**Attachment 2
NRC3-11-0002**

Markup of Fermi 3 FSAR, Revision 2

Markup of Detroit Edison COLA
(following 11 pages)

Supplemental Response to RAI letter related to Fermi 3 ER

Figure 4.3-1 Fermi 3 Impacts to Undeveloped Areas (yellow lines) on Fermi Site (red line)

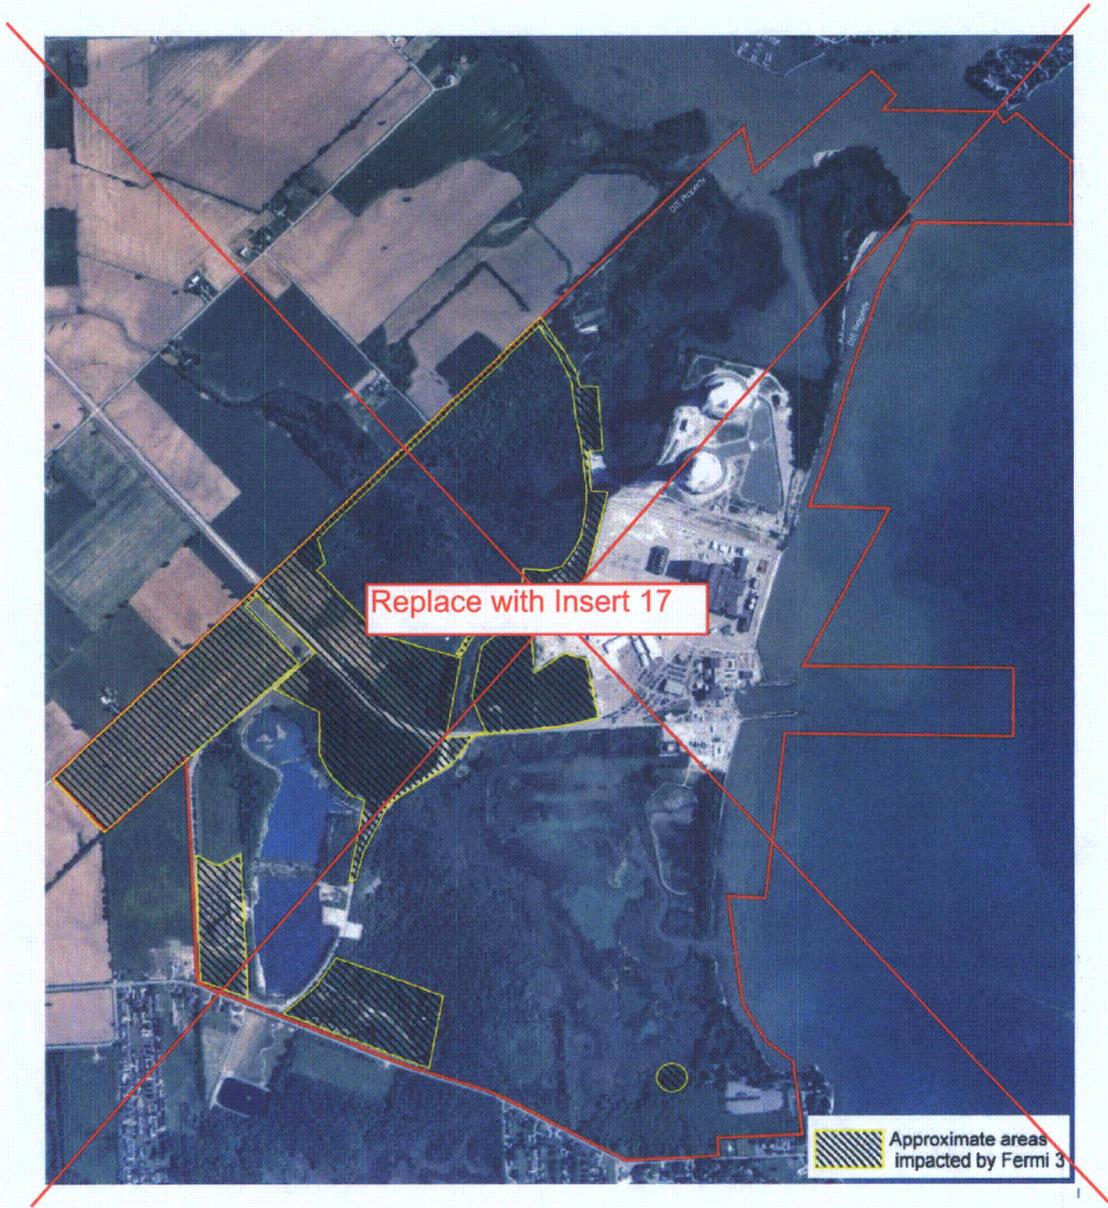
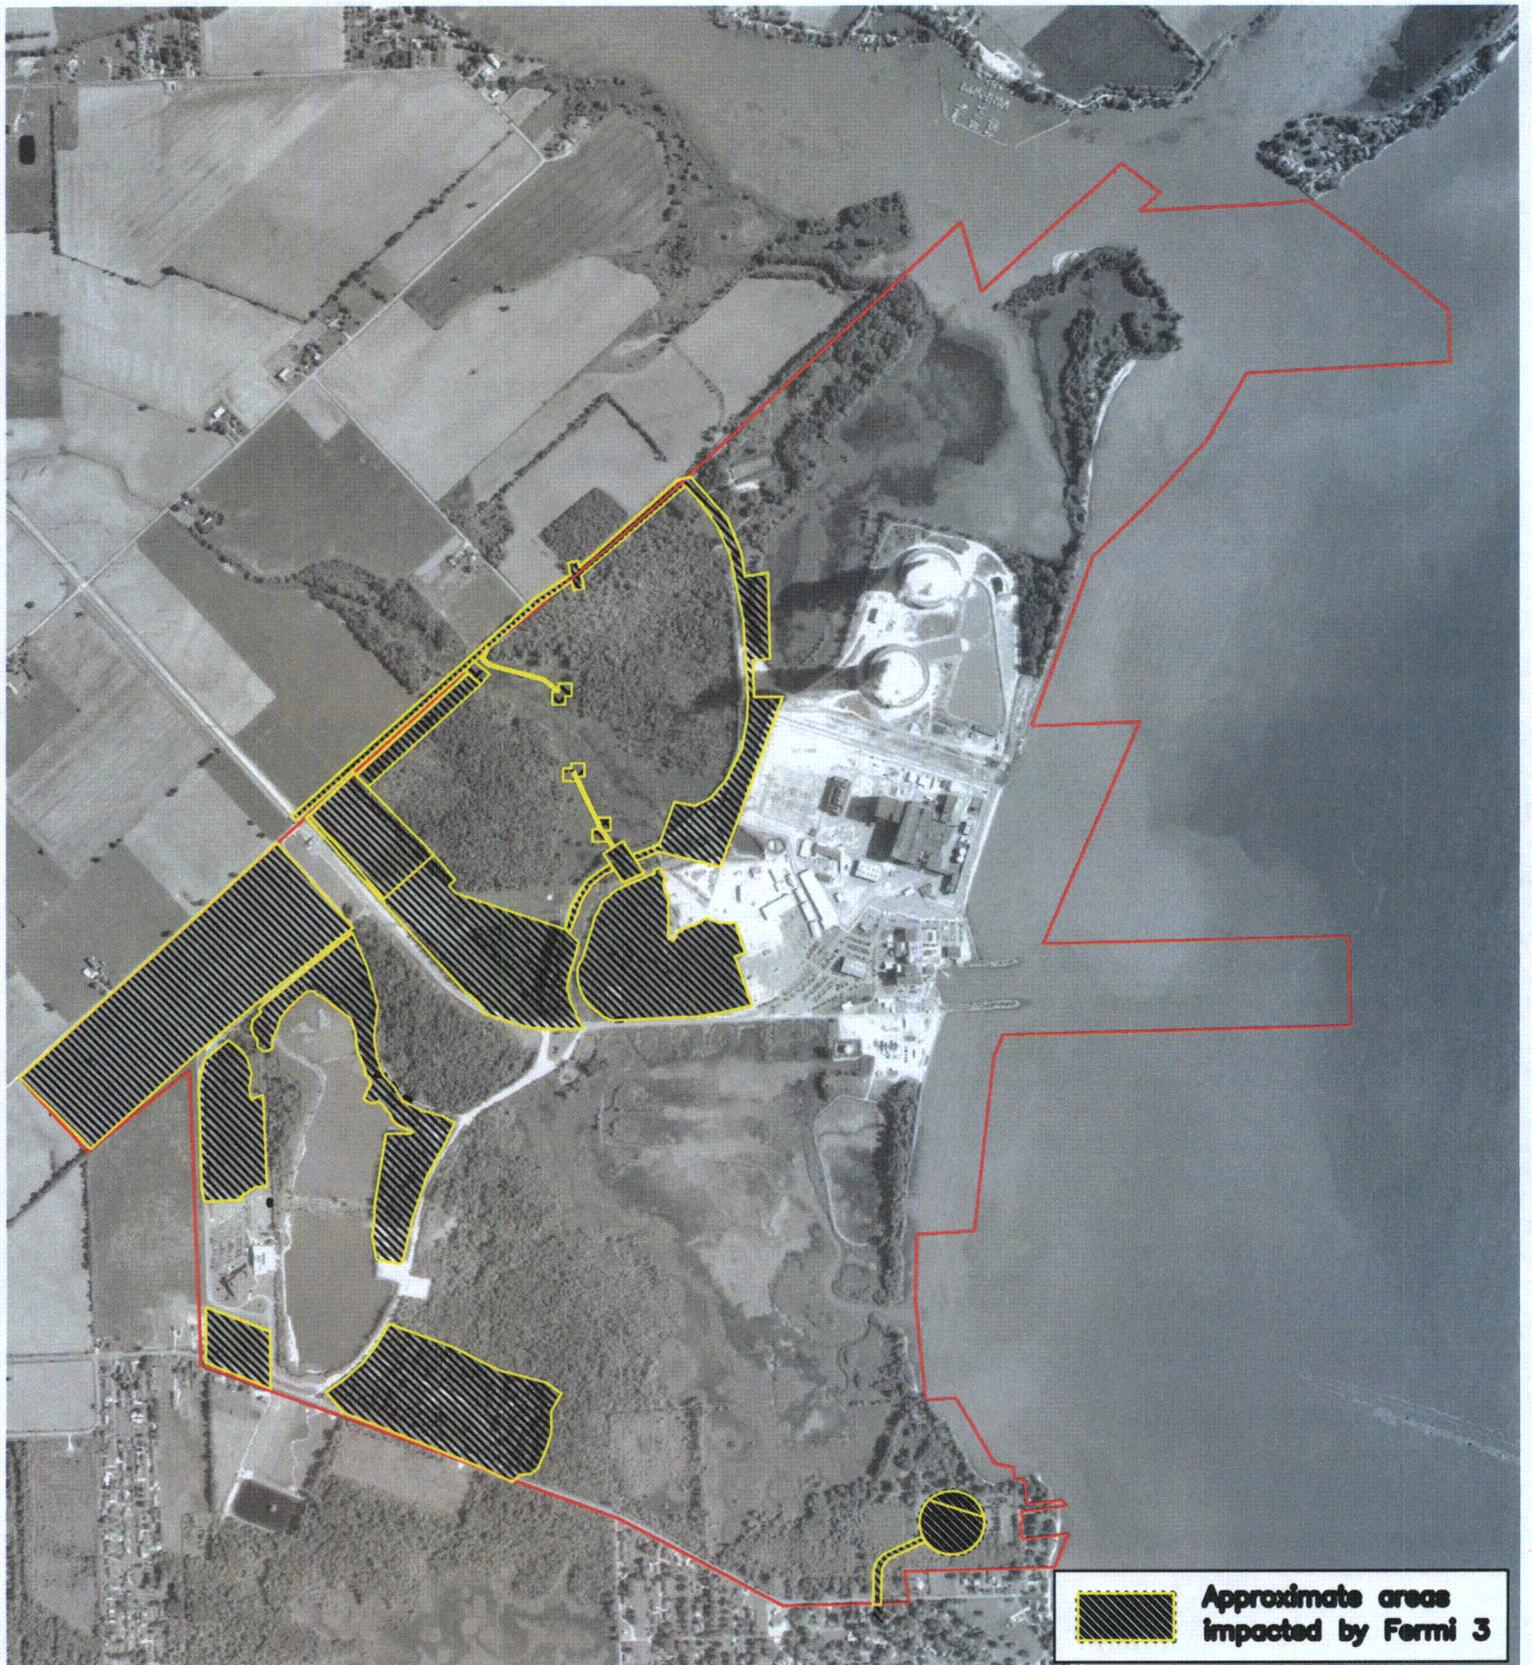
ER Markup	Description of ER Markup
Figure 4.3-1	Revised to reflect new site layout.
Figure 4.3-2	Revised to reflect new site layout.
Figure 4.3-3	Revised to reflect new site layout.
Figure 4.3-4	Revised to reflect new site layout.
Figure 4.3-5	Revised to reflect new site layout.
Table 4.6-1	Revised to clarify that the discussion pertains only to offsite transmission, as the new site layout proposes the construction of an onsite transmission system.
Section 4.7-1	Revised to reflect changes to acreages due to the site layout revision.
Section 4.7-4	Revised to reflect changes to acreages due to the site layout revision.
Section 4.7.4-1	Revised to reflect changes to acreages due to the site layout revision. Revised to clarify that the American Lotus will be impacted by filling of the south canal. Revised fox snake discussion.
Table 4.8-1	Revised to reflect changes to acreages due to the site layout revision. Revised to clarify that the discussion pertains only to offsite transmission, as the new site layout proposes the construction of an onsite transmission system.

Insert 17 Figure 4.3-1
